Detailed responses to Reviewer #2

Review of “Evaluating low-cost NDIR CO₂ for atmospheric observation in rural settings”

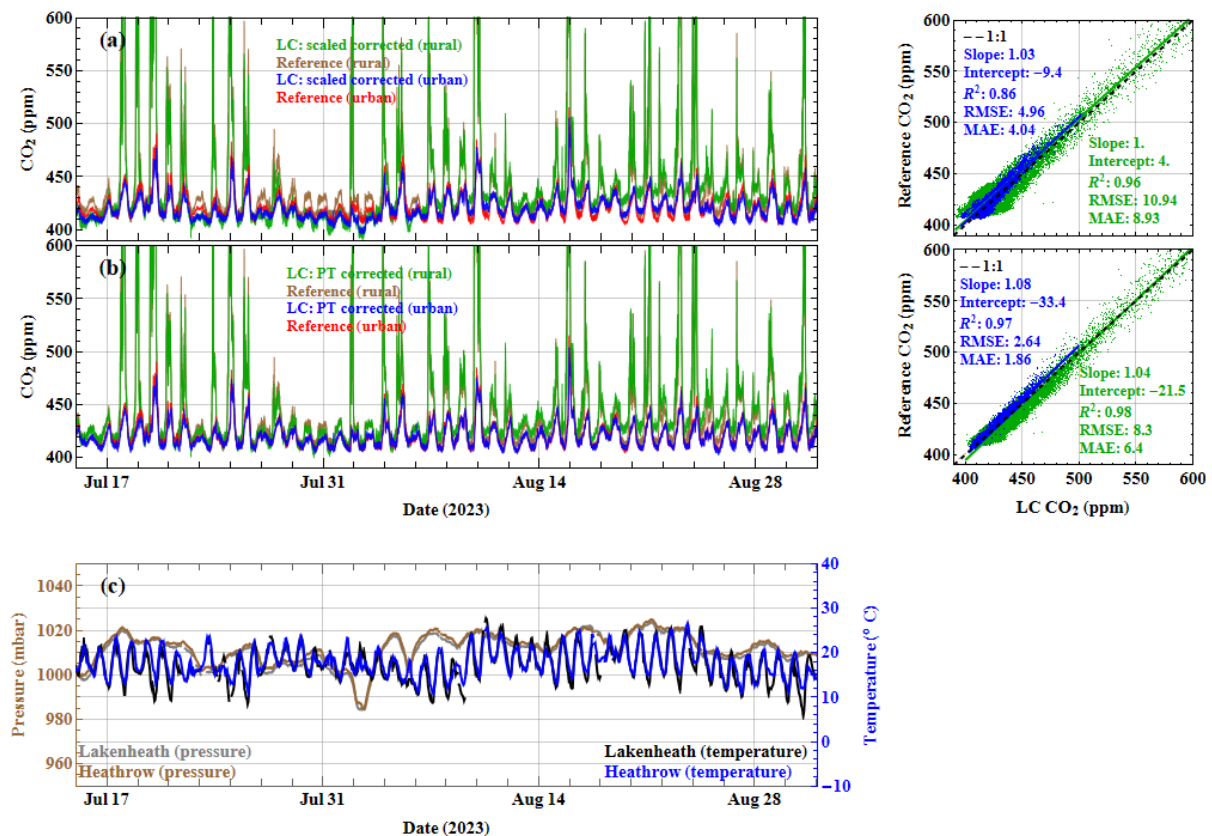
1. The results suggest that the tested LCS are not yet sufficiently reliable for deployment in rural environments, whereas they appear to perform more effectively in urban settings.

The general average trend may be comparable but signal-to-signal observations between LCS and reference analyser is not well in the rural setting.

- **L401:** Section 3.4 (“Suitability of LCS CO₂ in rural applications”) appears to be the core of the rural evaluation. However, this section lacks statistical analysis. Furthermore, Figure 8 is not clearly explained and does not effectively support the narrative presented here.

We would like to thank the reviewer for highlighting this concern. The authors acknowledge that the majority of the results presented in the manuscript demonstrate the performance of the LC devices in the urban setting, owing to data gaps during the long-term deployment of the LC AirGradient S8 at the rural site. We have now revised the manuscript to include results from periods when concurrent data were available from both the urban and rural sites, thereby demonstrating the reliability of the LC devices for measurements in rural settings (Fig. 6 is now Fig. 8 in the revised manuscript).

Thank you for your comments. We have updated the description of this section as follows:

“To assess the potential deployment of LC Airgradient S8 CO₂ monitoring in rural environments, we compared measurements from corrected LC units with those obtained from reference-grade instruments at two locations, as outlined in Section 2. Although simple linear scaling produced similar trends to the reference data in both day-of-week diurnal and monthly plots, the LC measurements consistently underestimated CO₂ mixing ratios, particularly during the winter months approximately 10 ppm and 20 ppm at both urban and rural sites respectively. However, as illustrated in Figure 10 (b-d), the LC Airgradient S8 data corrected for pressure and temperature effects from the rural site show very good agreement with the reference measurements, both in terms of absolute values (see statistics in section 3.3) and temporal trends.”

Figure S4. Comparison of paired LC Magic-K33 units with the reference instrument during urban and rural deployments. (a, b) temperature, (c, d), RH, (e, f) CO₂ and (g, h) CO₂ time series at the urban (7-18 December 2022) and rural (20 December 2022-22 January 2023) sites, respectively.

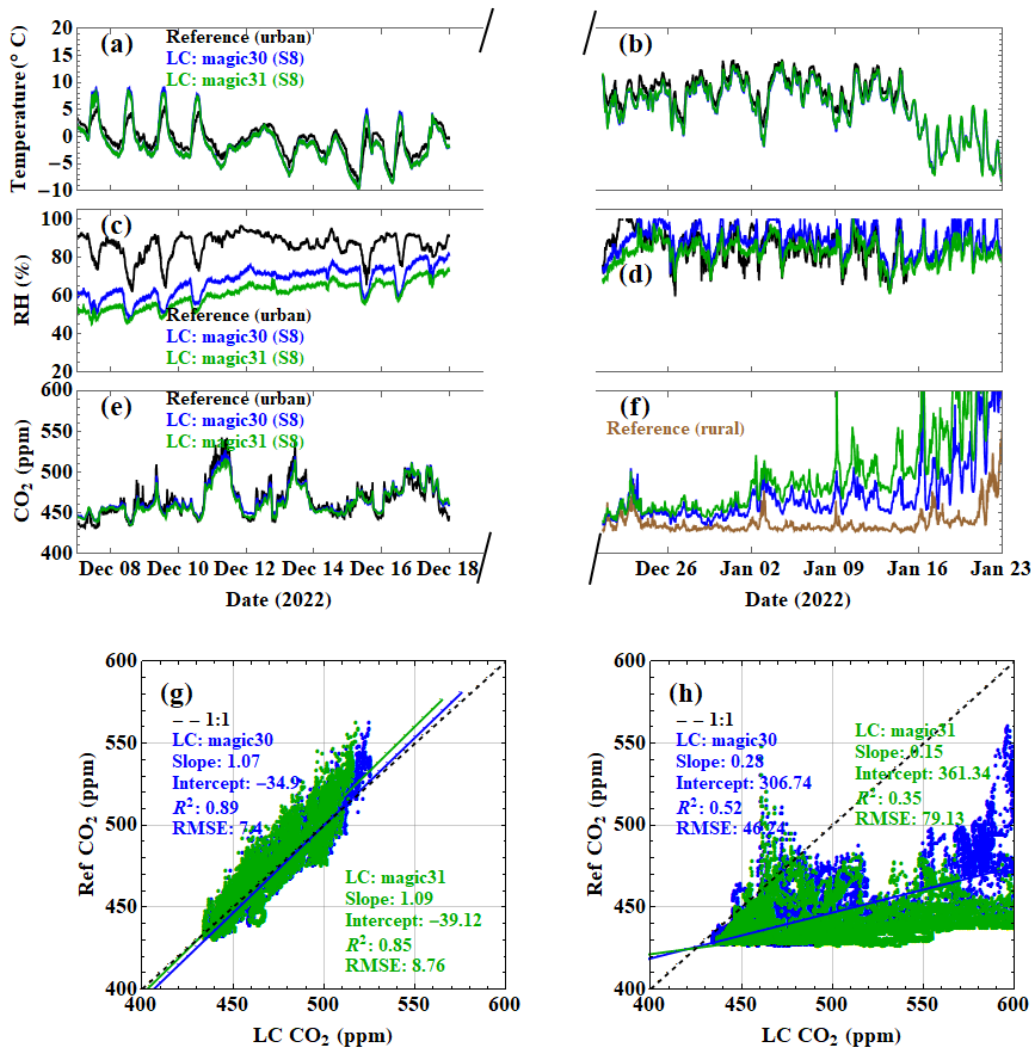
- **L28–29:** The authors recommend using the sensors as a reliable measurement source, but this assertion contradicts the findings presented in Figure 10, which demonstrate poor sensor performance in rural conditions. This discrepancy should be addressed.

We appreciate the reviewer's comment on this point. We suspect that the reviewer is referring to the rural deployment of the LC Magic K33 devices shown in Figure 11, rather than the earlier deployment of the same set of devices at the urban site shown in Figure 10.

The poorer performance at the rural site (Figure 11) is an artefact of the housing design of the LC Magic K33 devices, which made them more susceptible to higher local internal RH. We have revised this figure by combining it with Figure 10 and have moved it to the Supplementary Information (Fig S4) to avoid readers interpreting these results as representative of the general applicability of LC NDIR devices in rural settings. With this in mind, and considering the additional results from the rural deployment of the LC AirGradient S8 devices shown in Figure 6, we believe that the statement in L28-29 remains appropriate.
